91 BEATRICE CIRCLE

ARCHITECTURAL DESIGN PRESENTATION

JULY 12, 2021

SUMMARY OF REVISIONS

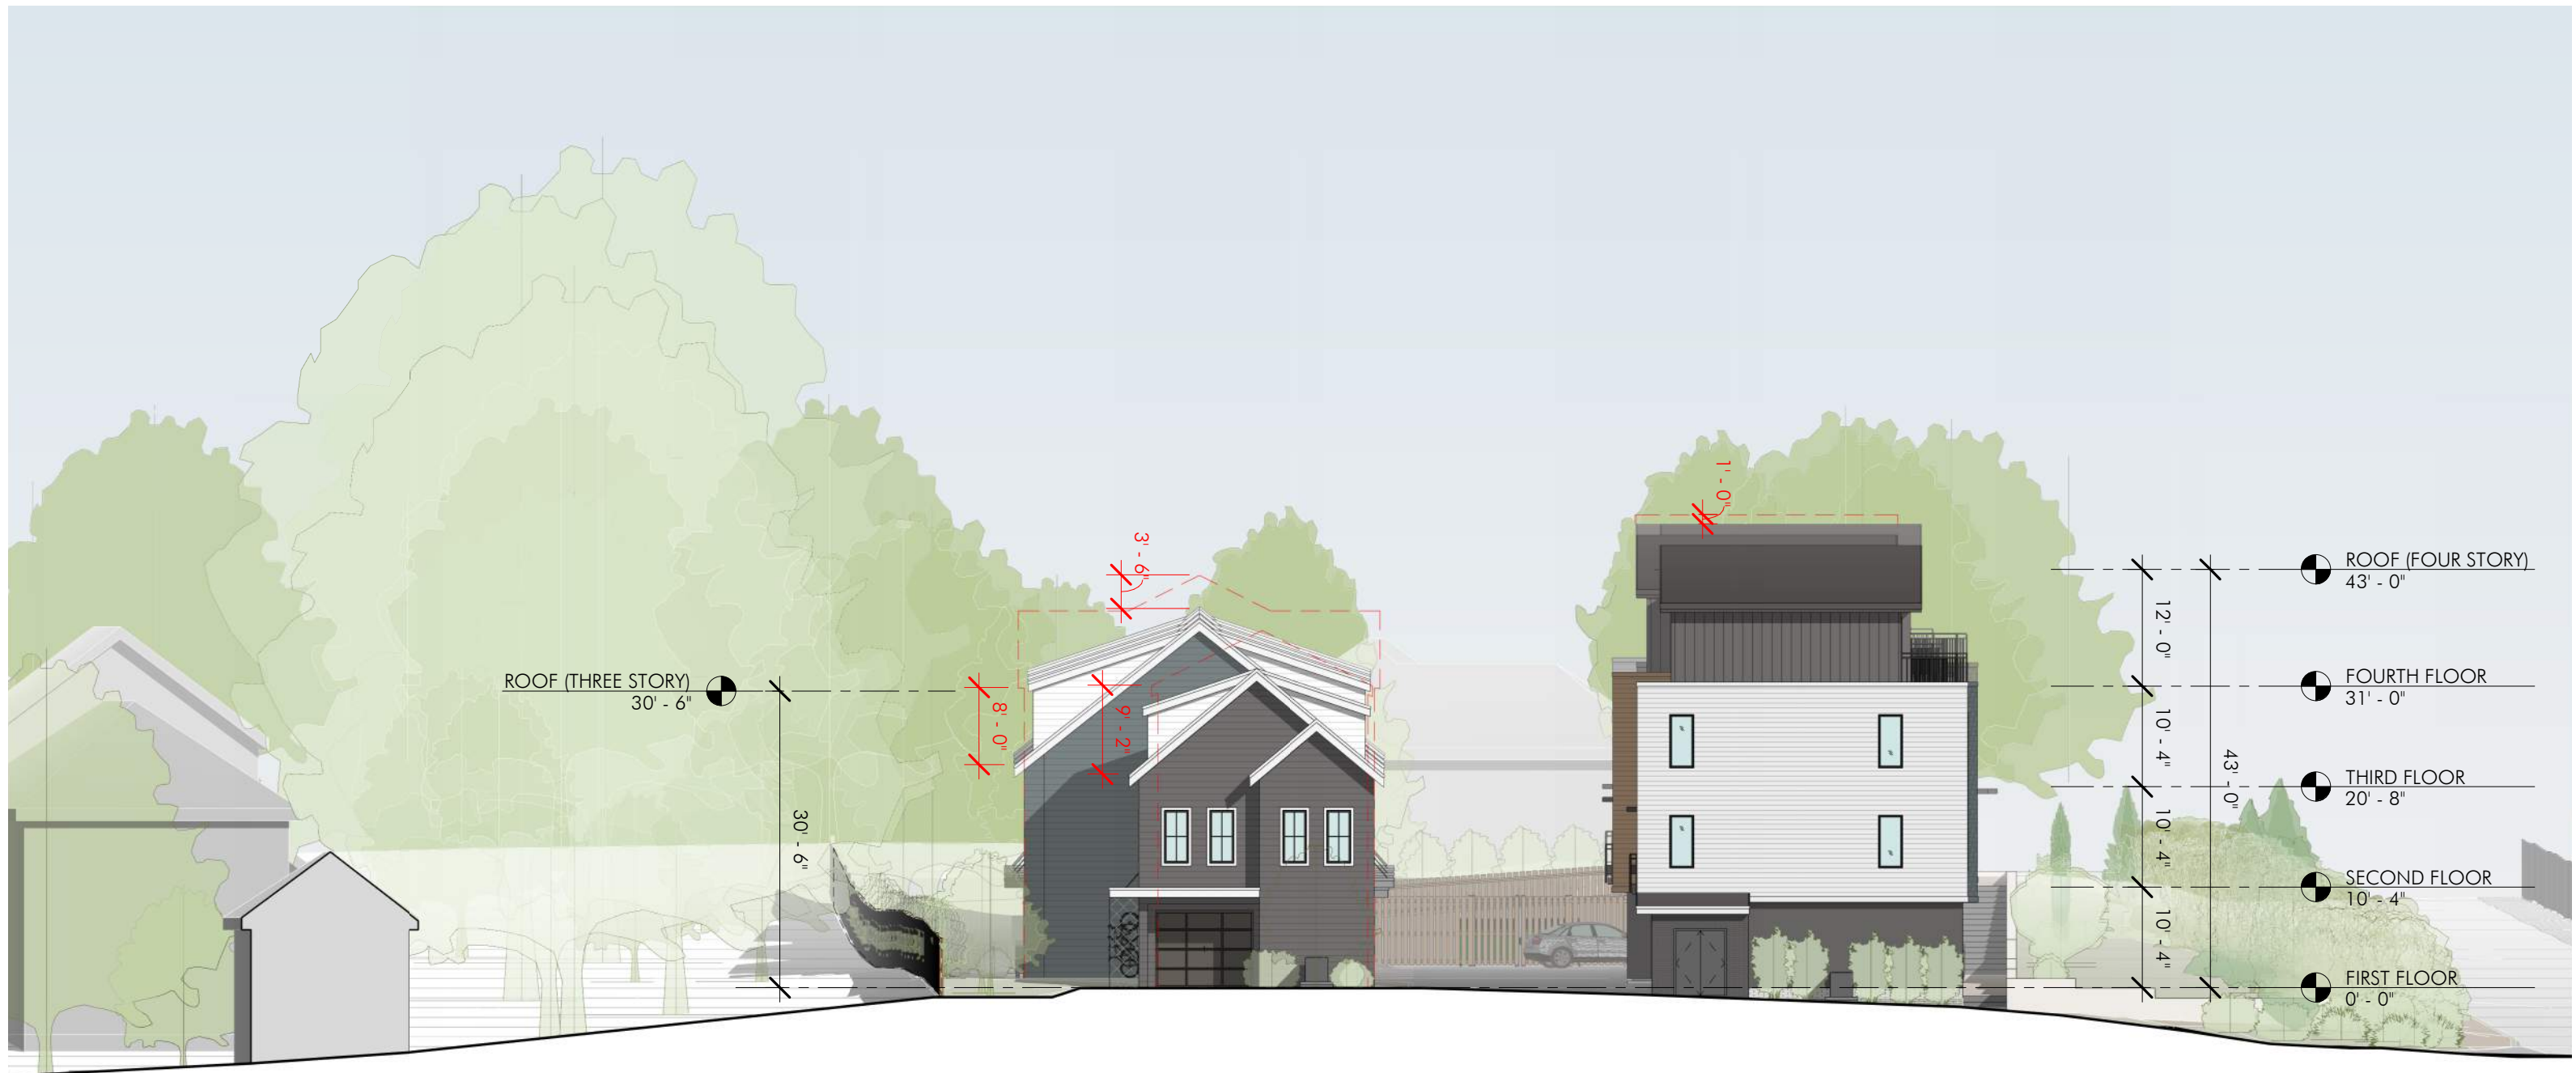
REDUCED IMPACT OF REAR TOWNHOUSES

THIRD FLOOR INCORPORATED INTO ROOF STRUCTURE

OVERALL ROOF HEIGHT LOWERED

SECOND FLOOR BALCONIES REMOVED

SUMMARY OF REVISIONS

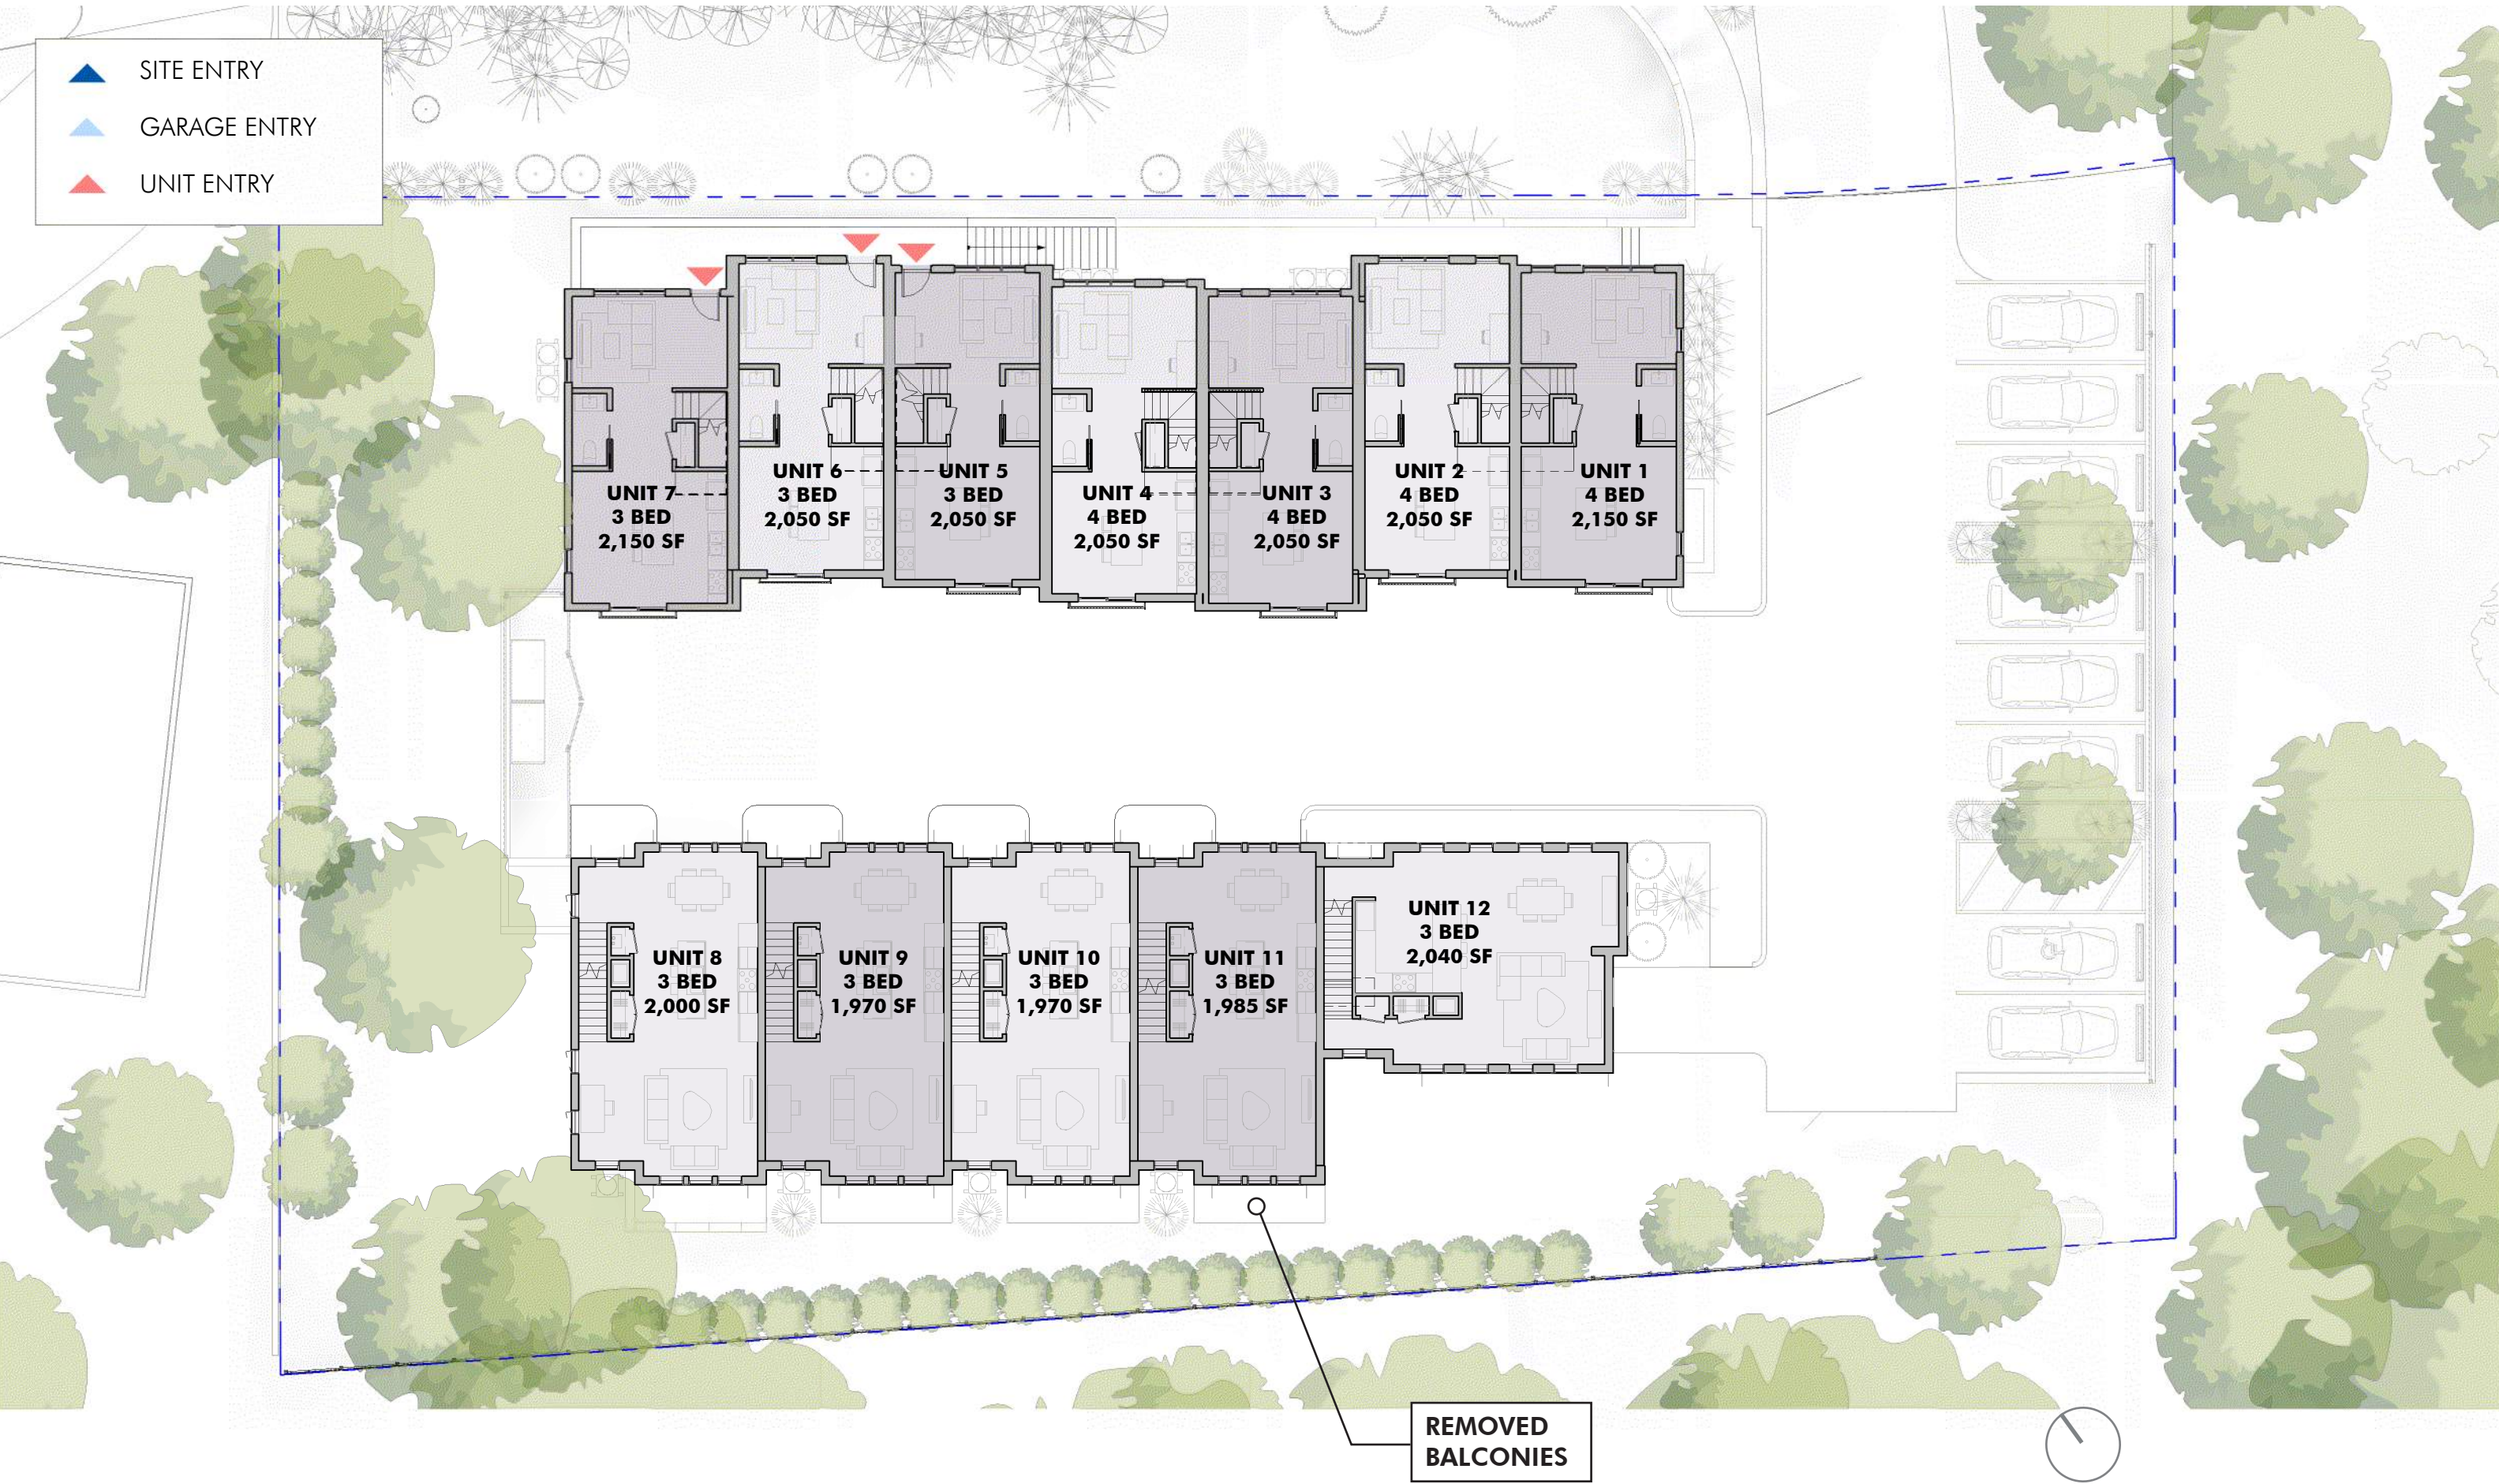
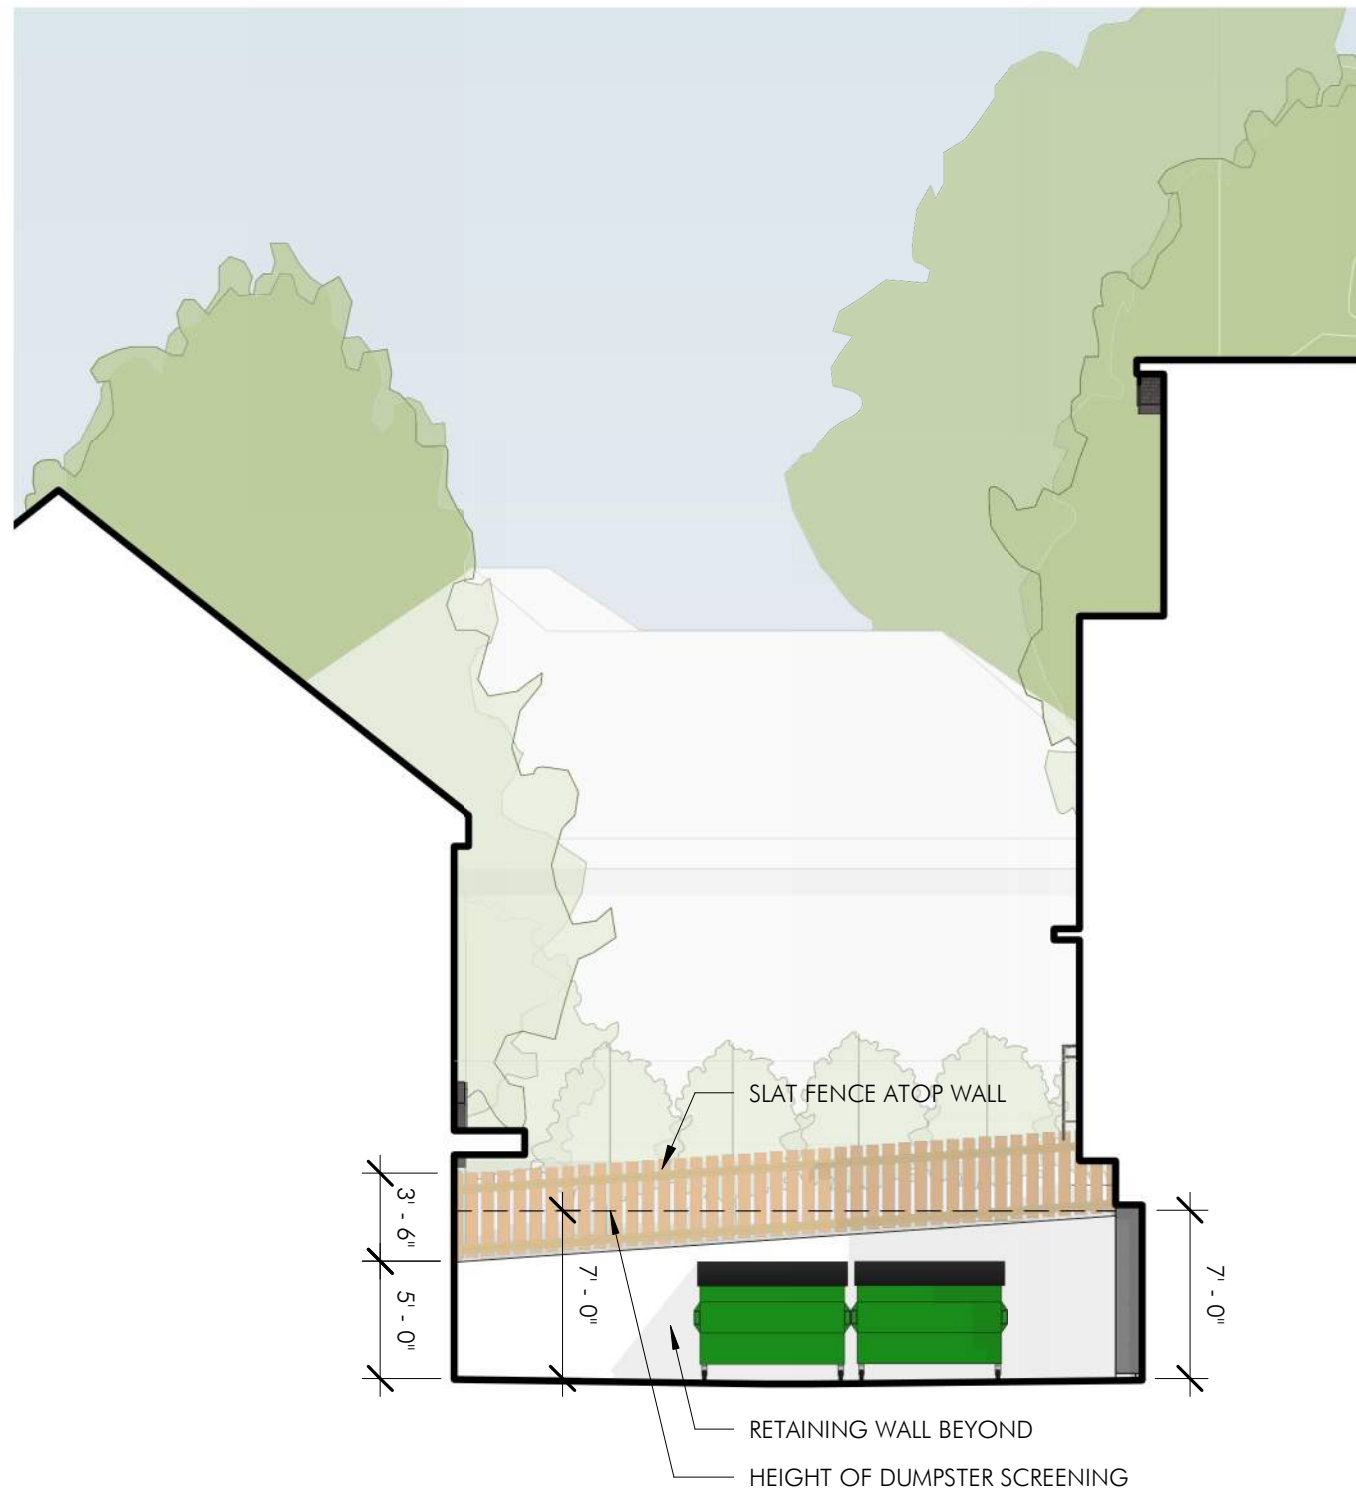
REDUCED IMPACT OF REAR TOWNHOUSES

RECONFIGURED ELEMENTS OF SITE PLAN

REDUCED IMPACT ON EXISTING TREES AT WEST OF SITE

RELOCATED SHARED PATIO SPACE

INTRODUCED ADDITIONAL PARKING SPACE

INCREASED CLEARANCE BETWEEN TOWNHOUSE ROWS
